OFFICE OF  
**FRESNO**  
**IRRIGATION DISTRICT**

May 17, 2012

RE: Review of High Speed Rail 15% Plans for Segment 1B (Stanislaus to Santa Clara streets) and 15% Plans for Segment 1C (Santa Clara Street to South of American Avenue)

FID Facilities: Braly No. 14, Fresno Colony No. 24, North Central No. 26, Central No. 23, Viau No. 25, and Storey No. 237

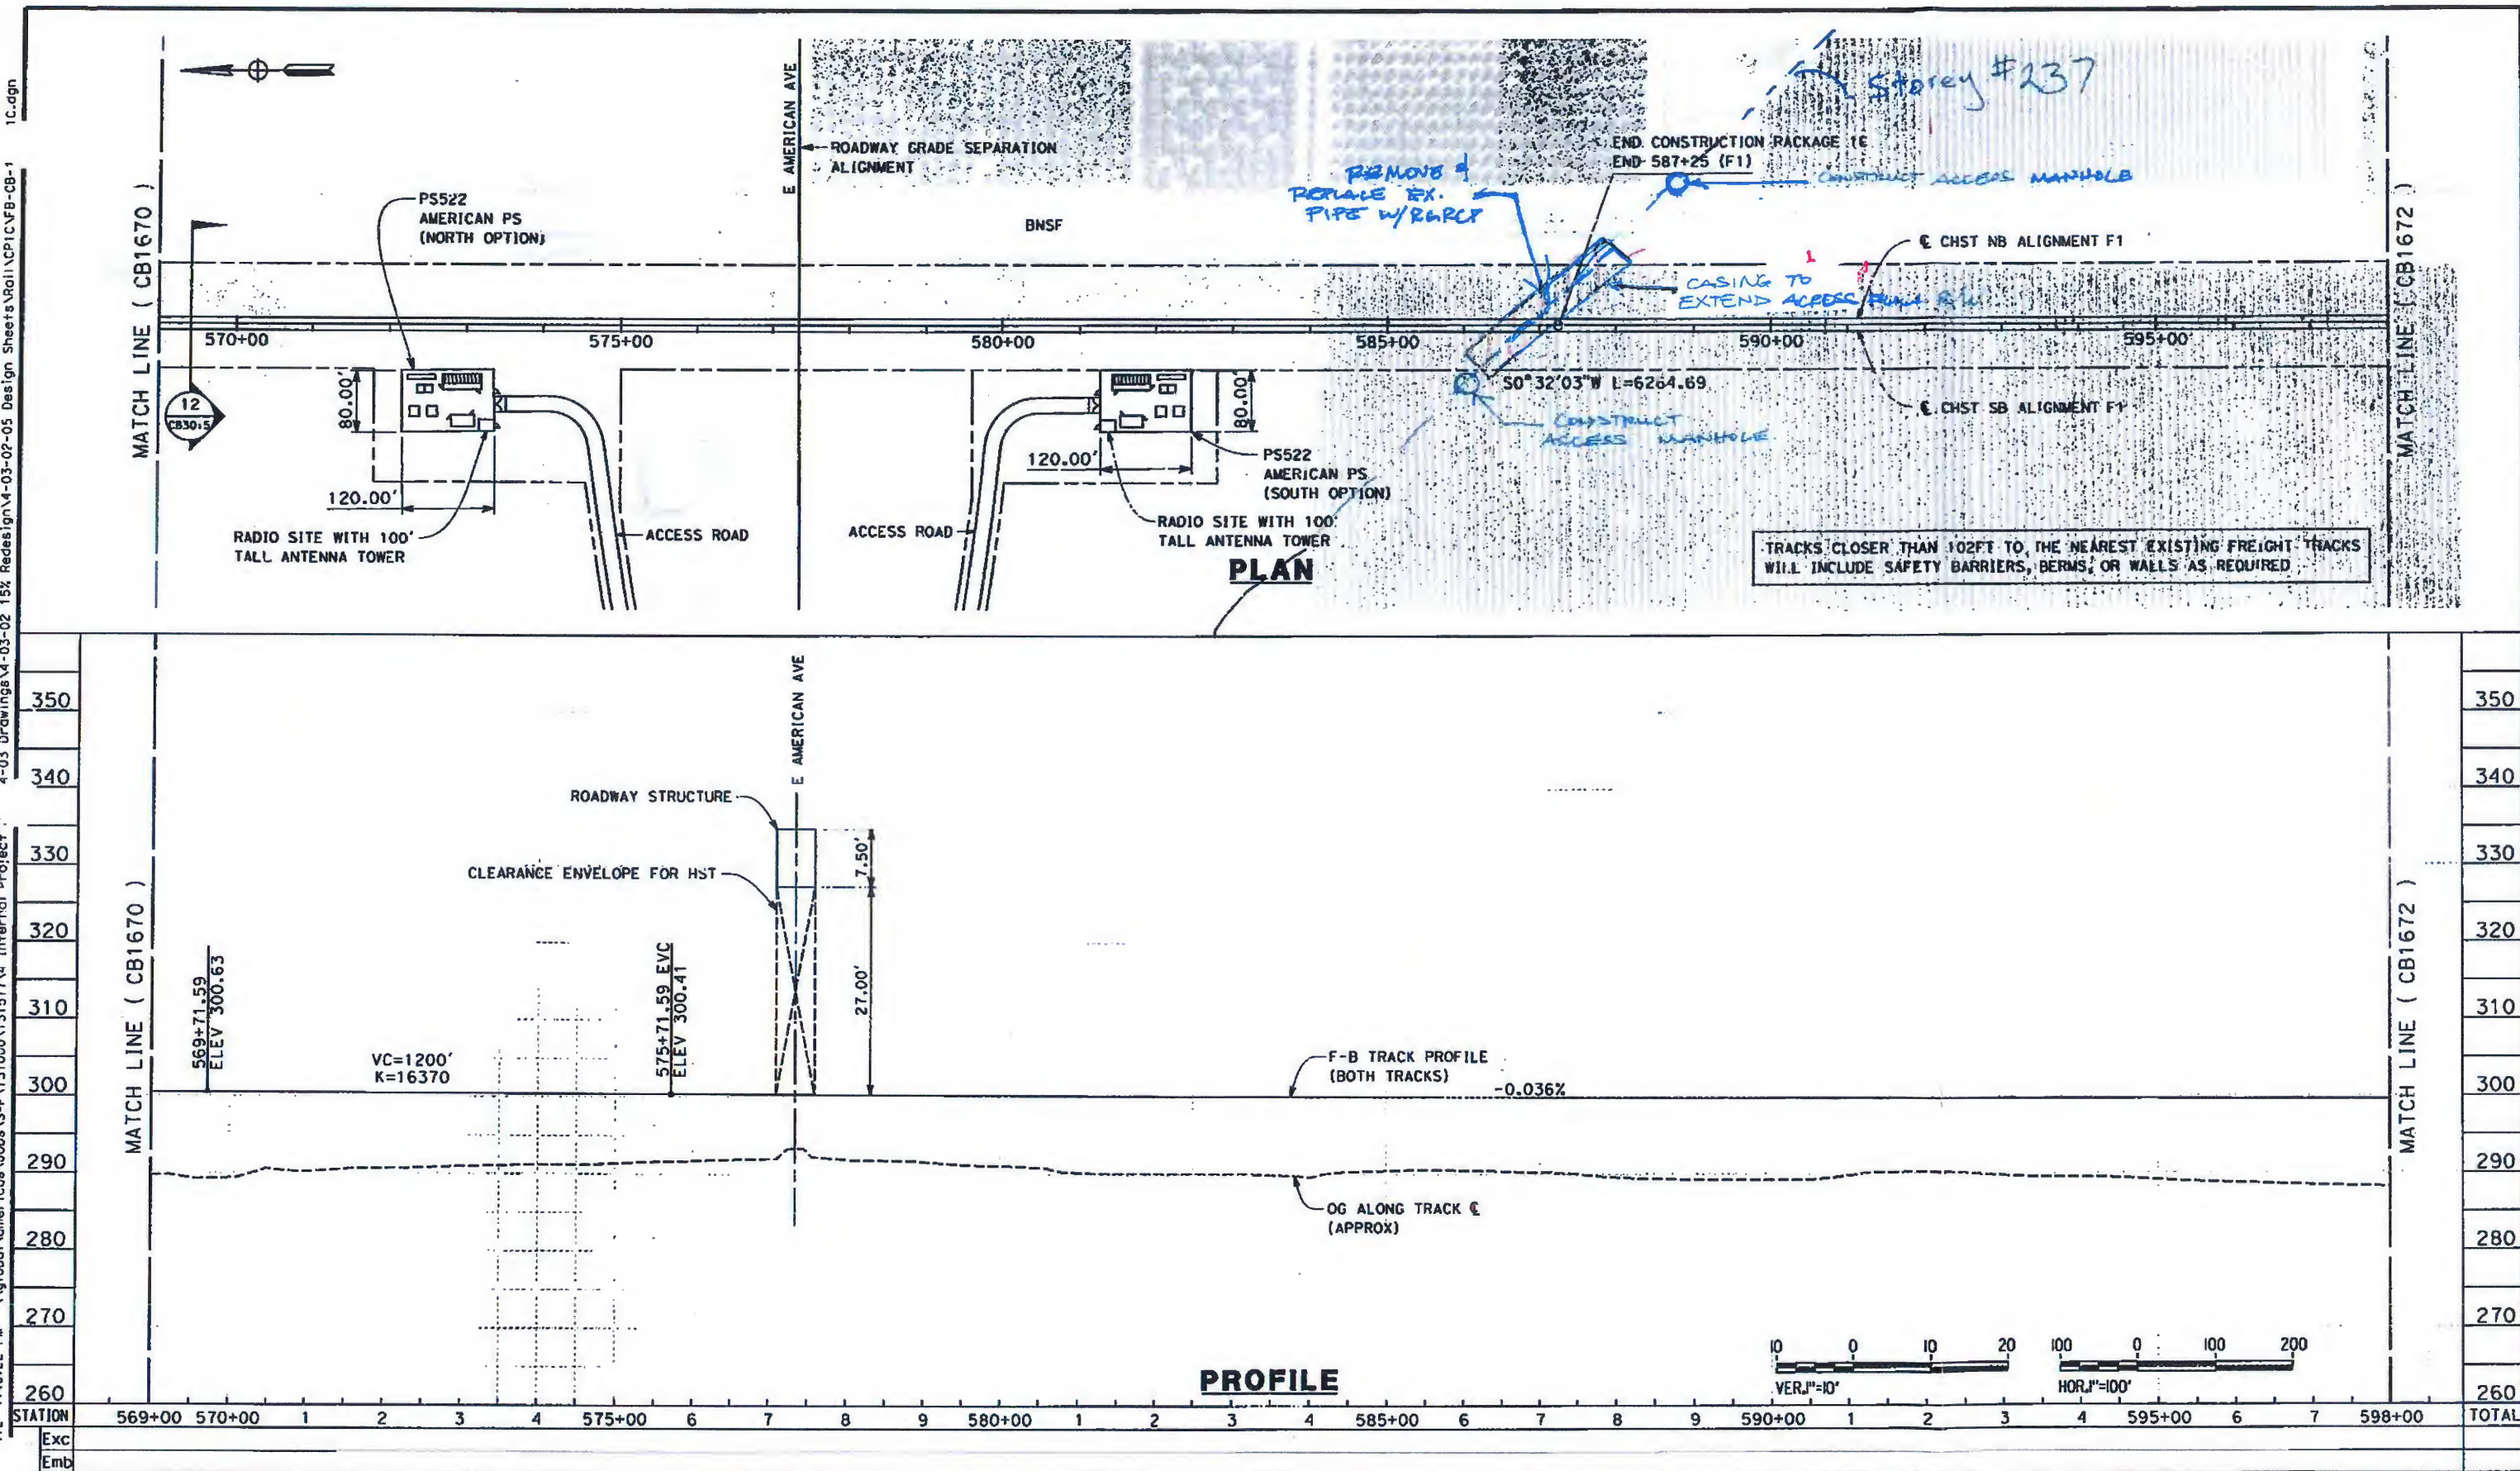
- Provide a plan/profile along the centerline of FID's facility, and include locations of other utility crossings in plan and profile views.
- The existing pipeline shall be removed and replaced with new ASTM C-361 RGRCP. The existing pipe within the CHSRA's right of way is not suitable to remain in-place with heavy equipment operating over it. The additional loading and vibration that the existing pipeline will experience will compromise the pipe. Protection of pipe is not an acceptable mitigation method. A 60-inch diameter access standpipe with galvanized steel bar grating metal cover shall be constructed on both sides of the right in conformance with FID requirements for urban setting.

- The new casing shall extend across the full right of way width. More detail is needed to understand the location of construction/receiving pits and the extent of construction to determine the work within the BNSF right of way. It is anticipated that the casing and new pipe will need to extend across the BNSF right of way as well, as a structure to connect to the existing pipe will be needed and is not desirable or accessible within railroad right of way.

- A 30-foot wide easement will be required for the new pipeline.
- Label the facility name and add the facility to all appropriate plan sheets. The Storey No. 237 is currently not reflected on any plan sheets.

- Plan sheets reviewed include CB1671, CT1028. Please identify any other sheets that cover the area of this FID facility.
- For further clarification, attached are plan sheet markups on key sheets, and a copy of available record plans of the Storey No. 237 at the CHSR crossing locations.
